Millstone Nuclear Power Station, Unit No. 3

Revised Three-Loop  
Radial Peaking Factor Limit Report

Suggested Revision to  
Technical Specification 4.2.2.2.2.e  
and Revised Three Loop Radial Peaking  
Factor Limit Report

Examples of  $F_{xy}^L$  Using the  
Current and Proposed Relationships

FIGURE 2

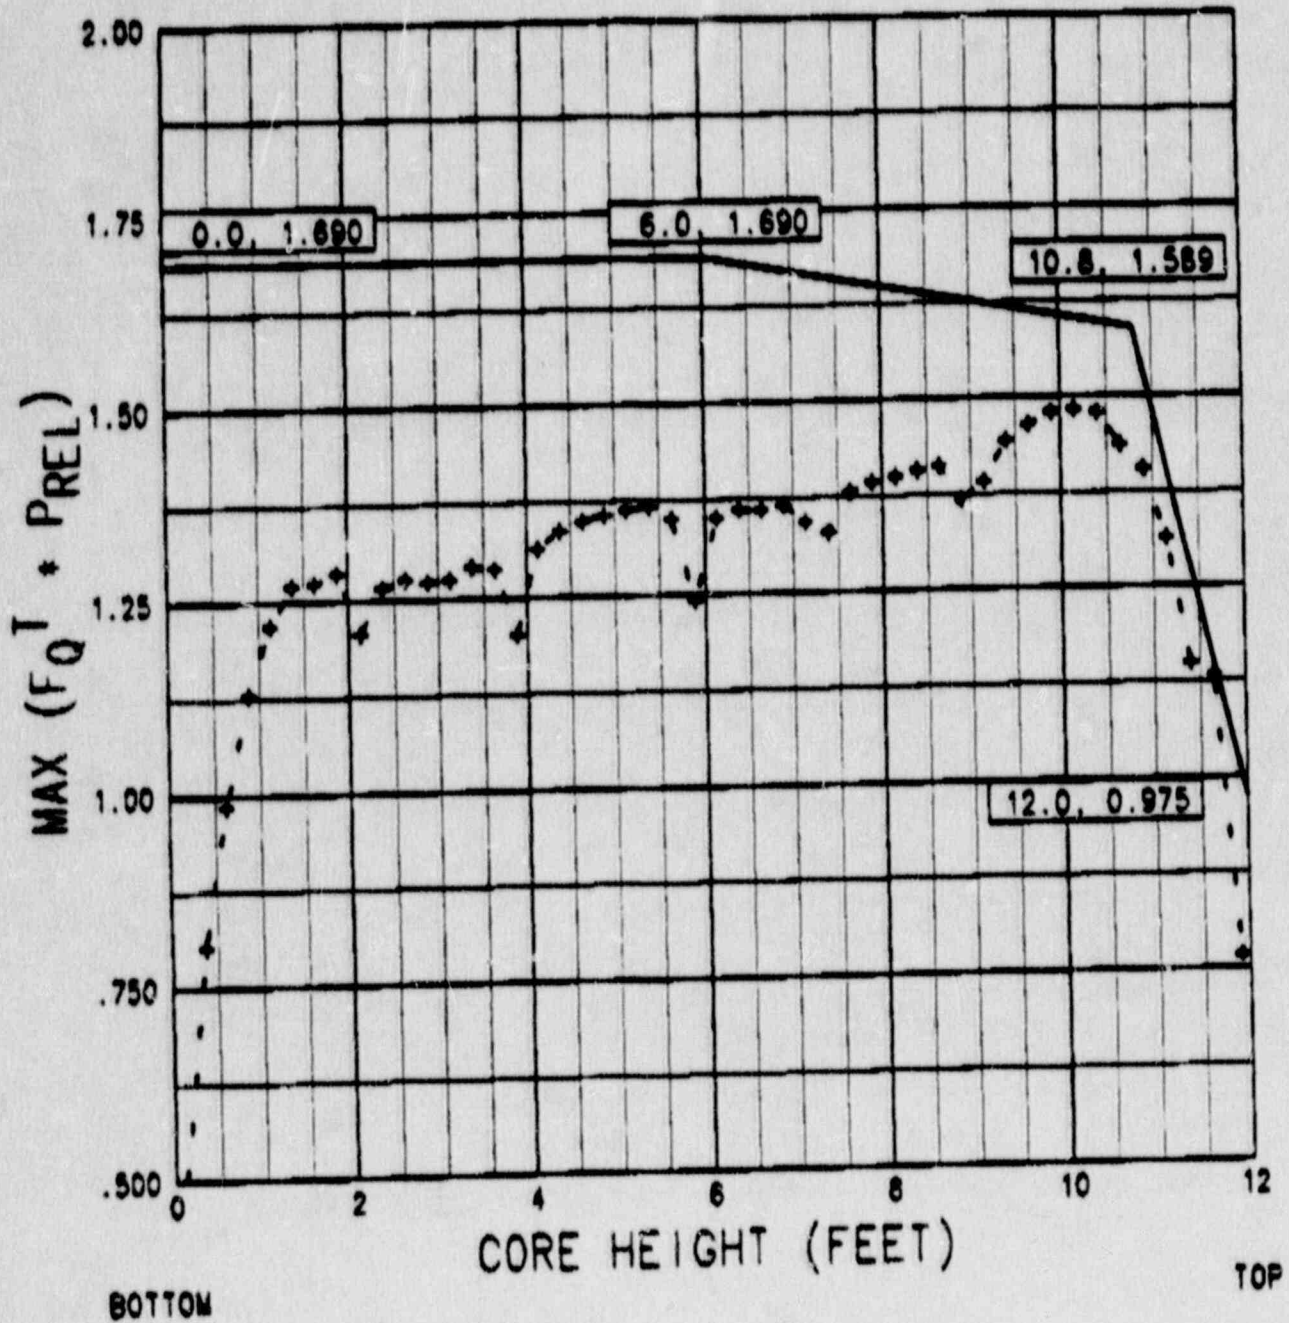
The three loop operation  $F_{xy}$  limits for 65% of RATED THERMAL POWER within specific core planes for Cycle 3 shall be:

1.  $F_{xy}^{0.65 \text{ RTP}}$  less than or equal to 1.81 for all core planes containing Bank "D" control rods, and
2.  $F_{xy}^{0.65 \text{ RTP}}$  less than or equal to 1.69 for all unrodded core planes.
3. In the relationship for  $F_{xy}^L$  the multiplier  $M_{Fxy}$  is equal to 0.281.
